# CITY OF ALBUQUERQUE

**Re: Retail at 7 Bar  
10080 & 10088 Coors Blvd NW  
Conceptual Traffic Circulation Layout for DFT Approval  
Engineer's Stamp 9-25-24 (B14D010D)**

<b>ENGINEER'S SEAL</b> RETAIL AT 7 BAR ALBUQUERQUE, NM	DRAWN BY pm/g6sb
	<b>TRAFFIC CIRCULATION LAYOUT</b>	DATE 09-25-24
	<b>TERRA WEST, LLC</b> 5571 MIDWAY PARK PL NE ALBUQUERQUE, NEW MEXICO 87109 (505) 858-3100 www.tierrawestllc.com	DRAWING
RONALD R. BOHANNON P.E. #7868	SHEET # <b>9</b>	JOB # 2023004

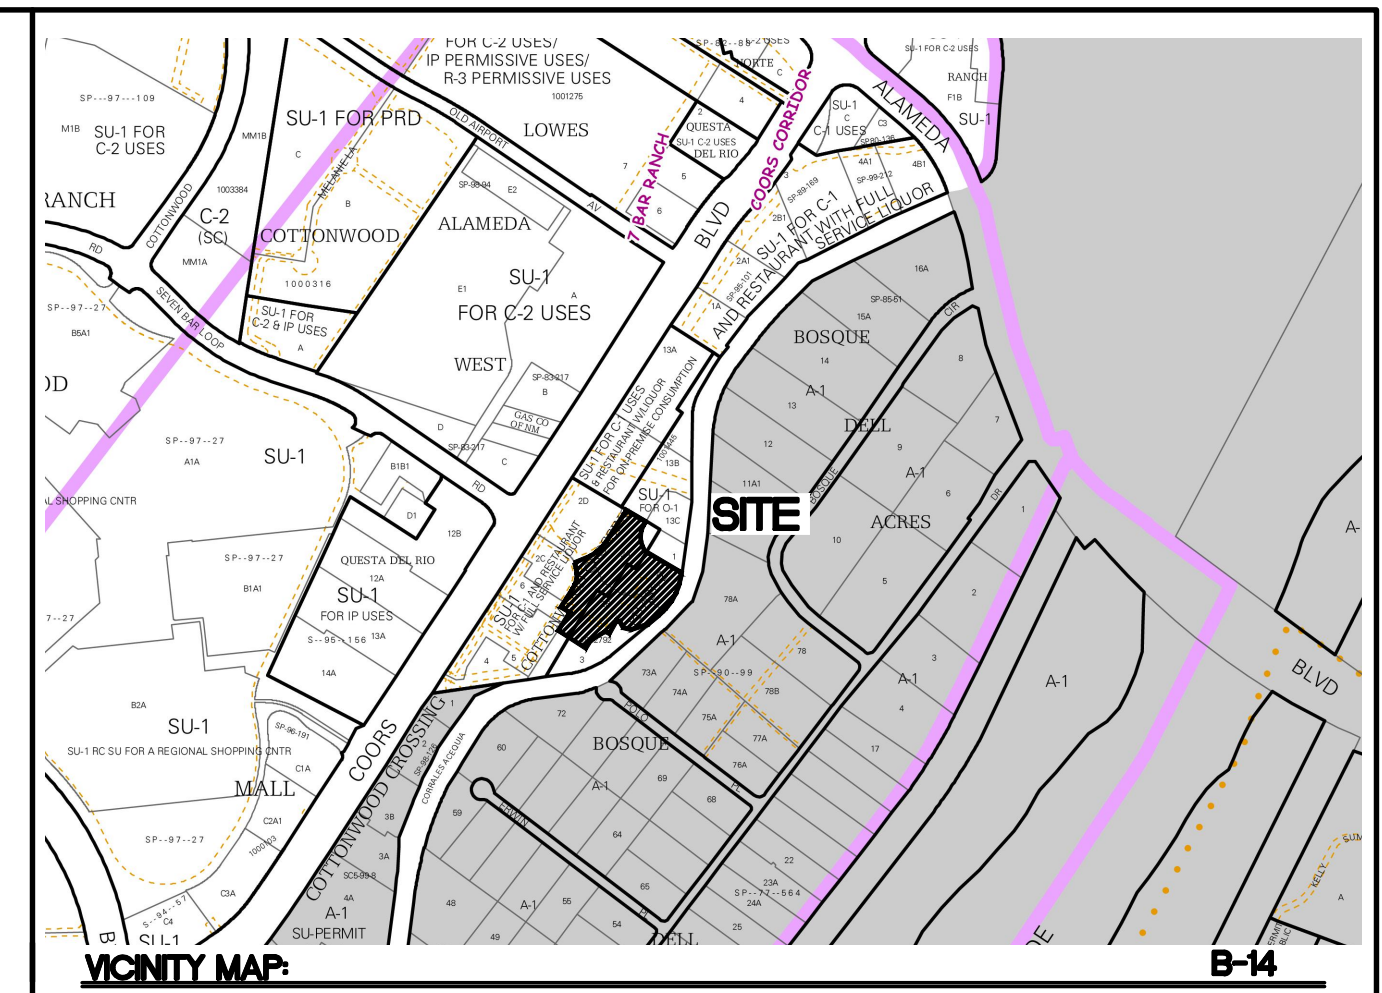
**1-A 5 ft sidewalk and 4-6 ft Buffer/Landscape are required along 7 Bar loop and the access road.**

**2-Show all the detail drawings**

**3-provide approval of fire marshal and solid waste dept.**

**4-submit TSF (see attached)**
